No. CB.72

DISCHARGED BATTERIES.

Rolls-Royce Silver Cloud	SWA.2 - SED.213
Bentley 'S' Type.	B.2.AN - B.632.EG
Bentley 'S' Continental	BC. 1.AF - BC.40.CH

Fig.1. Die-cast brush
carrier
(pre- "Q" type)

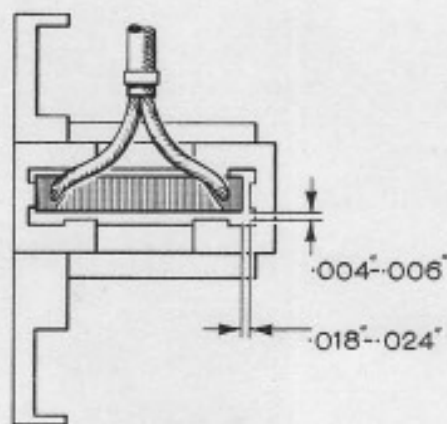
Investigation into the causes of electrical failure of the dynamo, has shown that the majority of this trouble on equipment modified as detailed in Bulletin CB.4, is due to sticking of the brushes.

Slight tilting of the brush in its carrier is permitted by the spring, and in order to accommodate this, it has been found necessary to increase the brush end clearance to $.018" - .024"$ by reducing the brush width. The existing face clearance of $.004" - .006"$ was found to be satisfactory (See Fig.1).

This modification has been incorporated on replacement machines supplied recently, but where trouble is encountered with any dynamo up to and inclusive of type "M", the brush dimensions

should be reduced, with a smooth file as necessary to obtain the clearance shown. Renew the brushes and clean the commutator if necessary, as detailed in Bulletin CB.4. Should excessive burning have occurred, a replacement dynamo must be fitted. Messrs. J. Lucas Ltd., are issuing instructions to their agents abroad, in order that this modification may be incorporated overseas.

Fig.2. Pressed strip
brush carrier
(Type "Q")

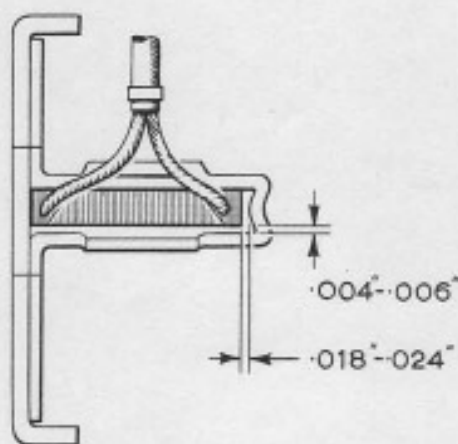
Some machines identified as type "Q" have been fitted. These incorporate pressed brass strip brush carriers in lieu of the standard die-cast boxes (see Fig.2). On these machines the brush end clearance was not increased above the existing value of .006" - .008" because of the danger of pronounced brush noise, with this type of carrier. It has now been found that increasing the end clearance to .018" - .024" does not increase the noise to an objectionable level, and these machines are being produced with the clearance amended accordingly.

In service, complaints of failure should be dealt with in similar manner to that detailed for the die-cast brush carrier machines.

Fig. 1.

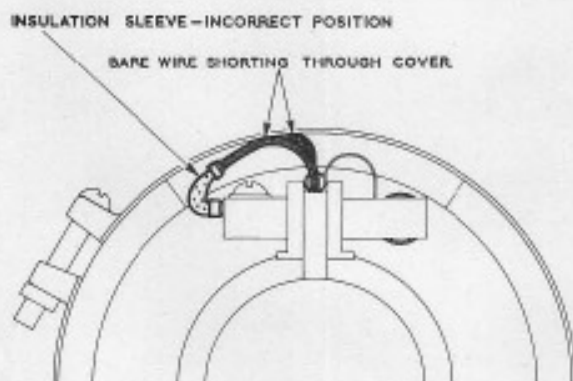
Dynamo charging failure has sometimes been caused by a short circuit between the brush flexible leads and the band cover. This will only occur if the insulation sleeves have been pulled back from their normal position, exposing the bare wires (see Fig. 1.). Rectify by stretching sleeves into their original position (see Fig.2).

Fig.1. DR 3. Type windscreen wiper motor.

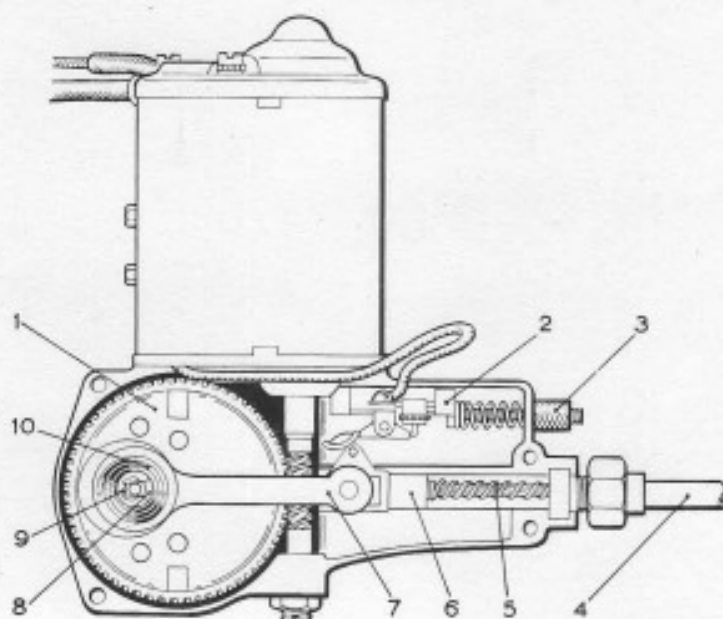
A new wiper motor (DR.3. type) is now being fitted to current production cars and by reason of its greater torque output and modified design, is an improvement on the DR.1. type motor which was fitted previously.

Installation on current production cars has been altered necessitating a reduction in the length of the first run of bundy tubing and also the use of a shorter rack.

A special mounting plate has been designed to enable the DR.3. type motor to be fitted for replacement purposes on cars previously equipped with the DR.1. type, without any alteration to the bundy tubing or rack being necessary.

Remove the circlip, which retains the connecting rod, followed by the plain washer, conical spring and shaped washer (see fig. 1.); care should be taken when removing the conical spring as it is under compression.
